# ***IMAX Darling Harbour***

*State Significant  
Development  
Modification  
Assessment  
(SSD 7388 MOD 10)*

April 2020

Figure 6 | Approved and proposed northern public domain (Base source: Public Domain Plans)

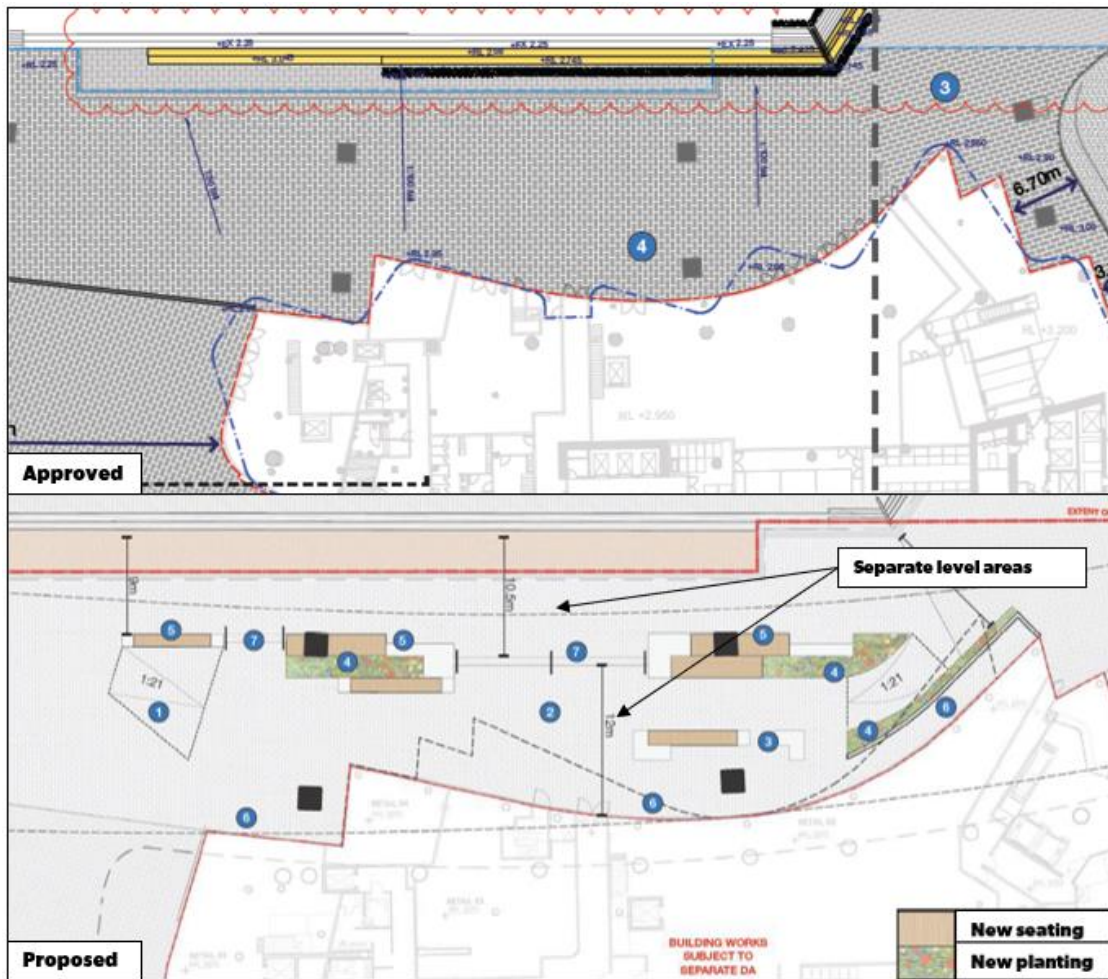
- the proposed public domain works are generally consistent with the original approval in terms of hard and soft landscaping and pedestrian circulation space (**Figure 6**)

**Figure 7 | CGI of the approved (purple) and proposed Port Cochere (Source: Applicant's Modification report)**

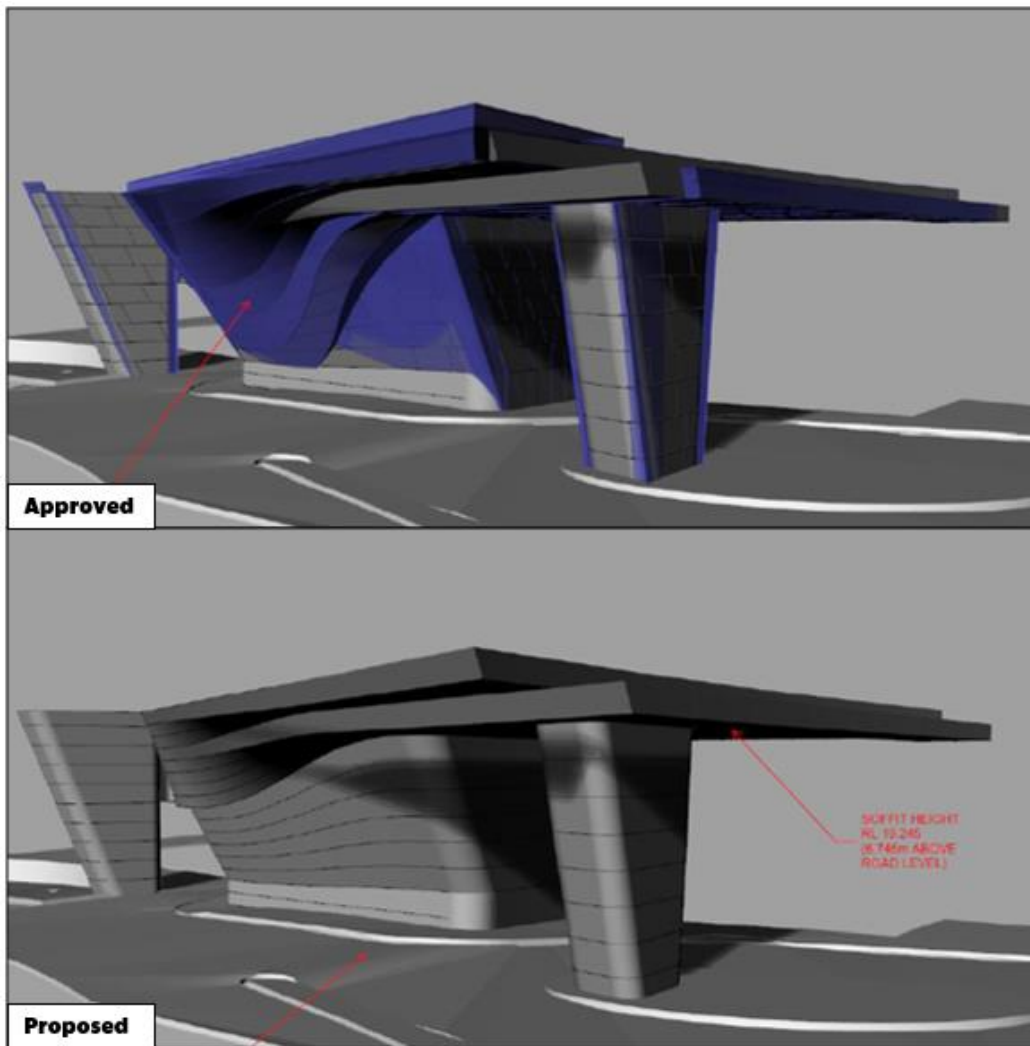
The proposal seeks to make minor amendments to the porte cochere of The Ribbon building to rationalise the curved steps in the eastern elevation and simplify the overall design (**Figure 7**). The modification will also result in an increase of the minimum pedestrian pathway width outside the porte cochere from 2.1 m to 2.5 m (**Figure 11**).

- it will result in a simpler more refined design which reflects the form and materiality of the approved Ribbon podium
- it would not impact the approved layout of the forecourt link road with respect to vehicle circulation and would increase the minimum vehicle clearance height above the road and adjacent pedestrian path
- it will reduce the severity of the existing pinch point in the pedestrian pathway increasing the footpath width from 2.1 m at its narrowest to 2.5 m.

**Figure 8 | Approved and proposed signage zones (Base source: Applicant's Modification Report)**

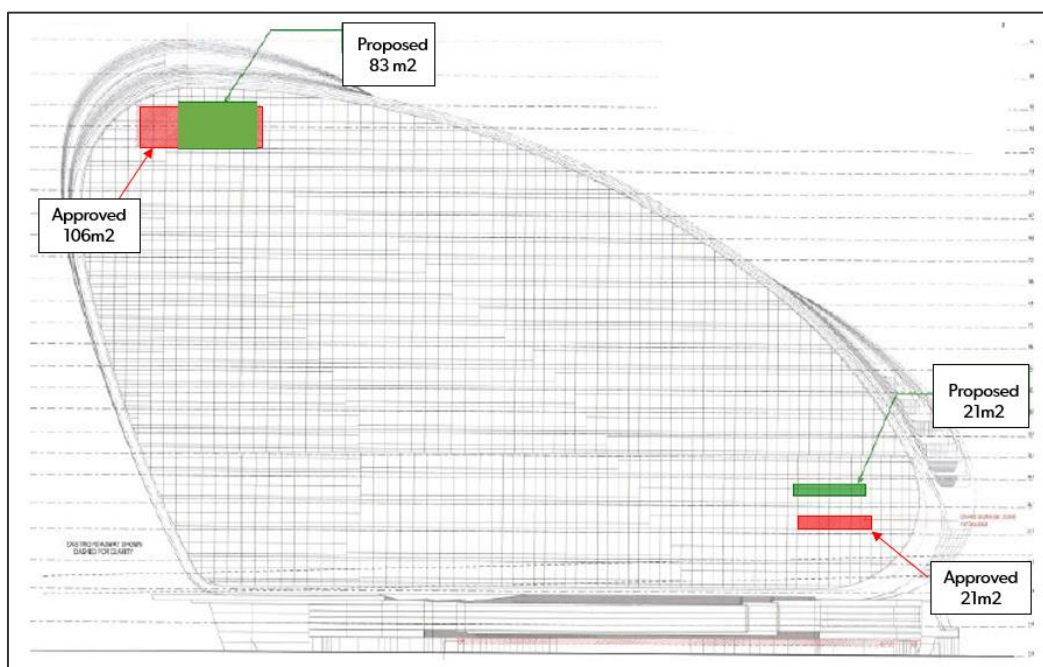
Signage zones	<ul style="list-style-type: none"> <li>• The modification proposes minor amendments to two approved signage zones on the northern elevation of The Ribbon building (<b>Figure 8</b>)</li> <li>• The upper level signage zone would be reduced in area from 106 m<sup>2</sup> to 83 m<sup>2</sup> and remain in the same location. The lower level signage zone would remain the same size as approved and move approximately 4 m above its approved location.</li> <li>• This change is sought to correct inconsistencies between the signage plans and photomontages approved under MOD 6 and reflect the size and location of the signage zones as shown in the photomontages.</li> <li>• The Department undertook a detailed assessment of the signage zones against SEPP 64 under MOD 6 and considers the proposed changes are minor and</li> </ul>	No additional conditions necessary

**Figure 10** | Existing and Proposed Property NSW building showing encroachment of the retained building into 2.0m RMS clearance zone.

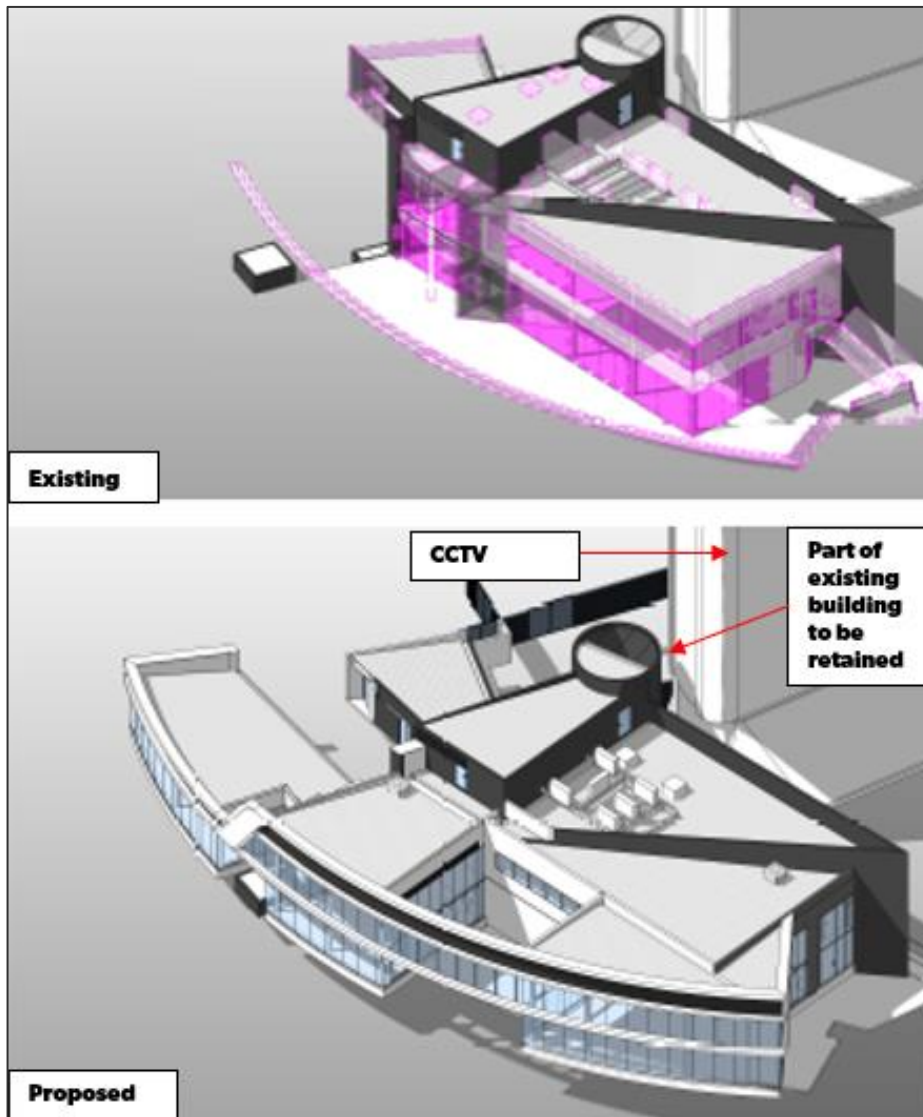
Council raised concerns about the wind conditions as a result of the amended façade design. TfNSW (RMS) raised concerns about the encroachment of the building into the 2.0m clearance zone of the Cross City Tunnel Vent (CCTV).

- submitted a wind impact assessment which demonstrates that the revised design of the building will not have a negative impact on wind conditions at ground level for pedestrians
- clarified that the only areas of encroachment result from the retention of part of the existing building (**Figure 10**). TfNSW (RMS) subsequently confirmed that their concerns had been addressed.

The Department has considered the proposal and the additional information provided by the Applicant to address concerns raised. The Department is of the view that the proposed changes to the Property NSW building are minor in the context of the overall development and the new curved design more closely relates to the approved podium and overall design intent of The Ribbon building. The revised design also retains floor to ceiling glazing as originally approved, providing an active frontage addressing the western public domain.

**Figure 11** | Plan showing the relocated palm grove, City Screen, event space and northern public domain  
(Source: RtS)

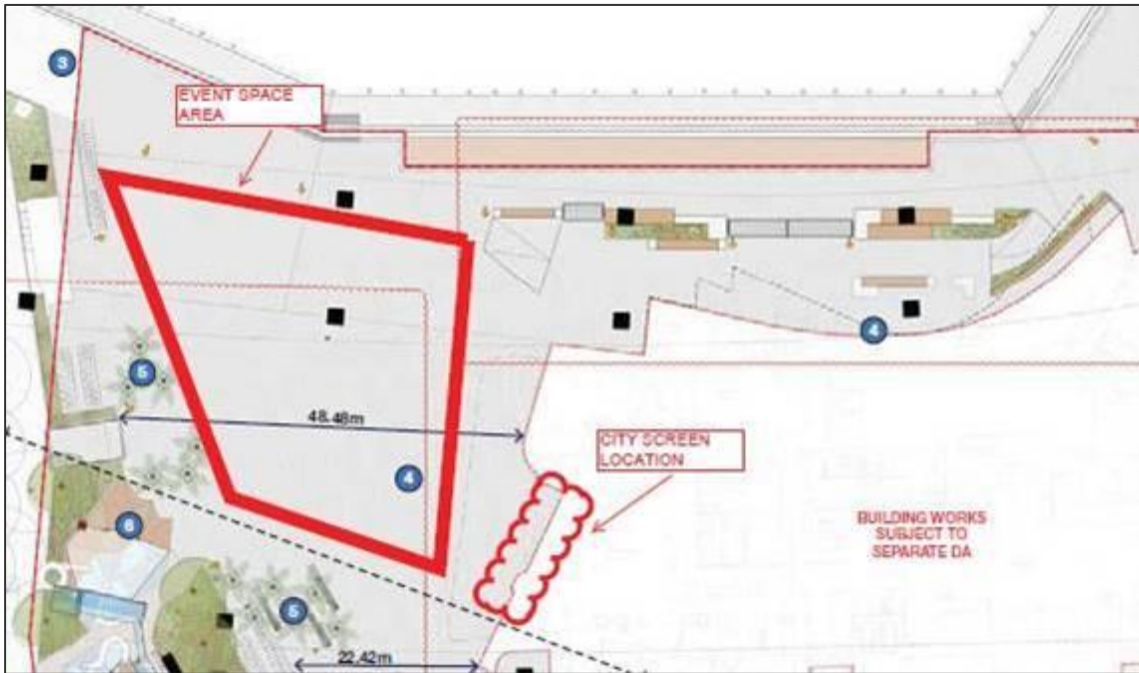
Council initially raised concerns about the impact of the relocated palm grove and northern public domain seating on views to the City Screen. Council also sought confirmation of footway gradings, drainage and minimum path widths adjacent to the proposed outdoor seating (subject to separate DA with Council) to north facing retail tenancies.

- the City Screen can't be seen from the northern seating area
- the location of the palm trees was chosen to tie into the playground and to enhance the amount of open space for public events within the public domain, and to maximise the viewing area for the City Screen (**Figure 11**)
- a 4.2 m clearance from the proposed outdoor seating is maintained
- the proposed levels within the stepped northern public realm provide adequate cross falls for drainage and to prevent localised pooling on footways.

The Department also supports the relocation of the palm grove to the south and west and considers it would not adversely affect views of the City Screen or the harbour and would increase permeability and usability of the event space area.
